ADDENDUM # 001

Holy Trinity Catholic School
60 Lorne Cres
Sarnia, Ontario

Classroom and Learning Commons
Renovations
Project No. 651-CP1828

April 4th, 2018

ASK-001

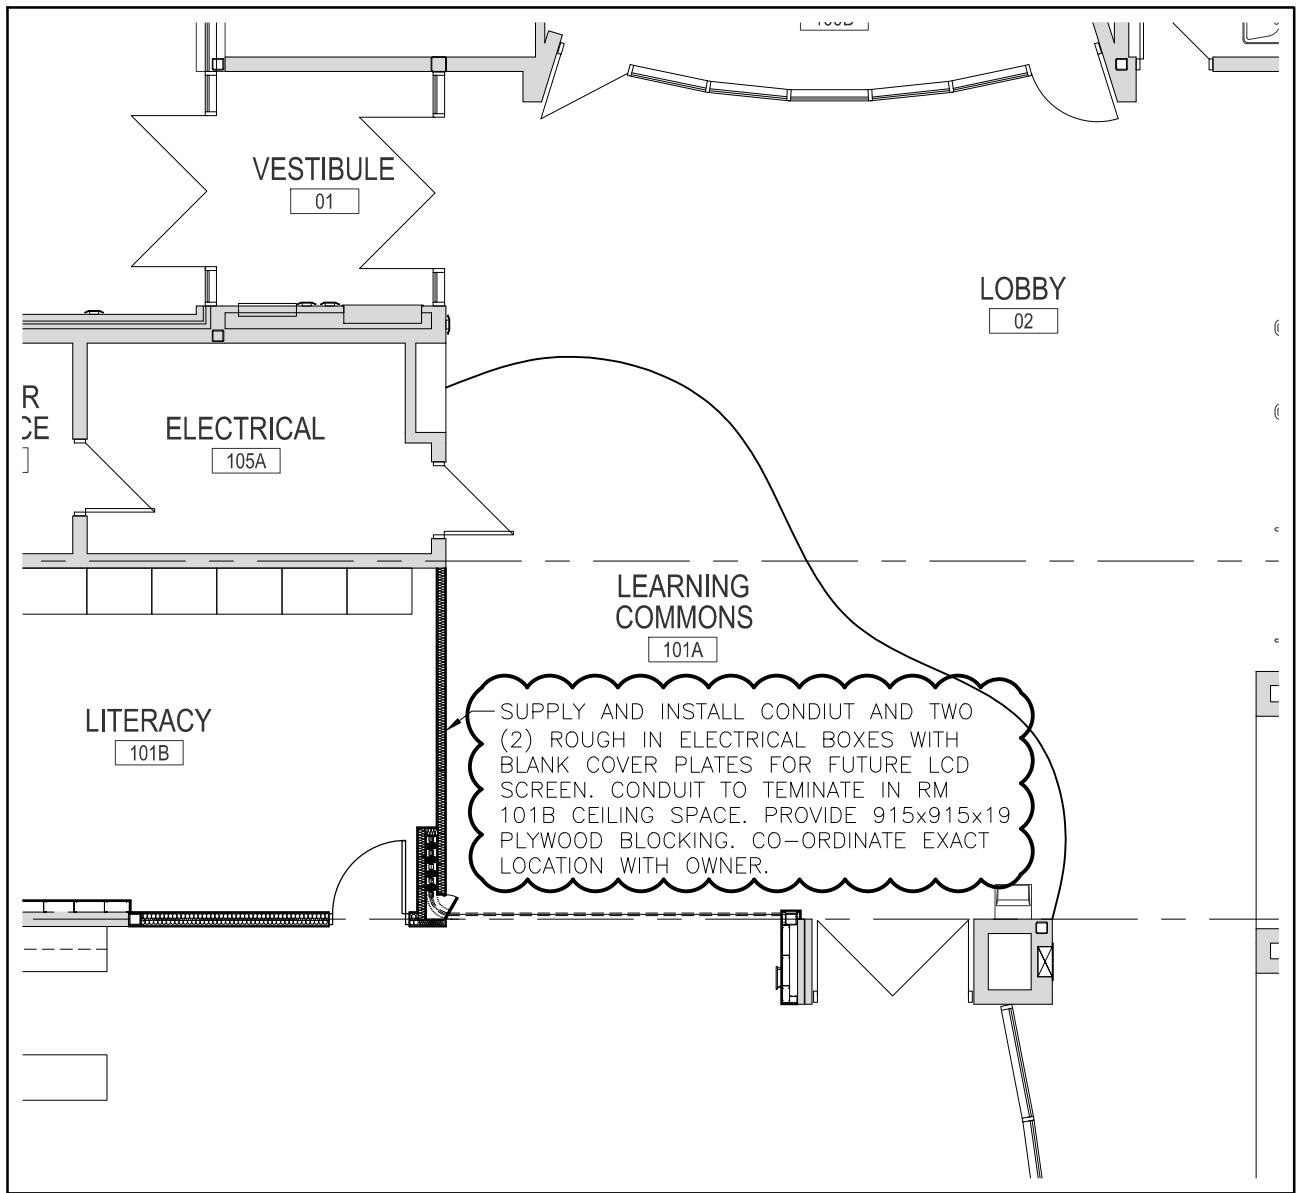
D100; Revise hoarding to allow for work to infill two doors opening in Corridor 10. All doors to Vestibule 11 to remain operable as they will be used by childcare.
